Product Change Notice

PCN#: EE-PCN23017
 07/21/2023

KR-5R5V105-R
KR-5R5V155-R

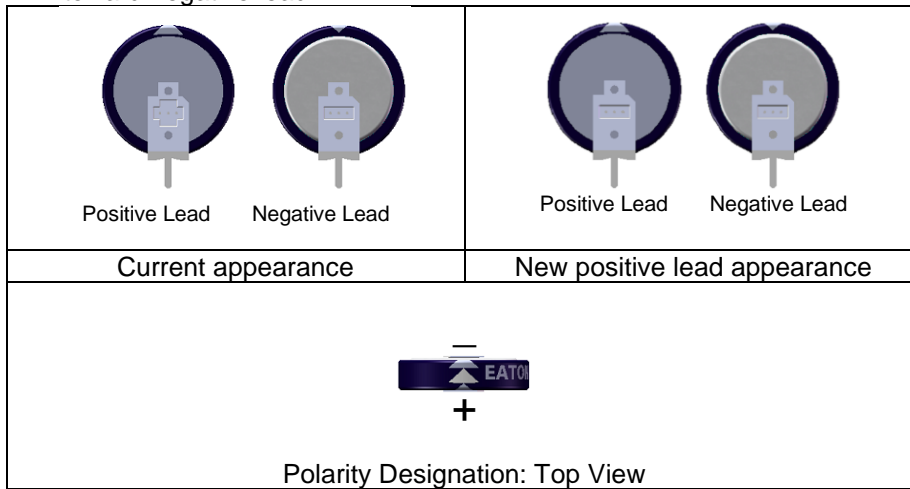
1. Tolerance of dimension P changing from ± 0.3 mm to ± 0.5 mm
2. Change of positive lead appearance. Polarity will continue to be determined by sleeve design pointing toward negative lead.

1. Specification to match actual production.
2. Quality improvement to avoid confusion with marking on the lead.
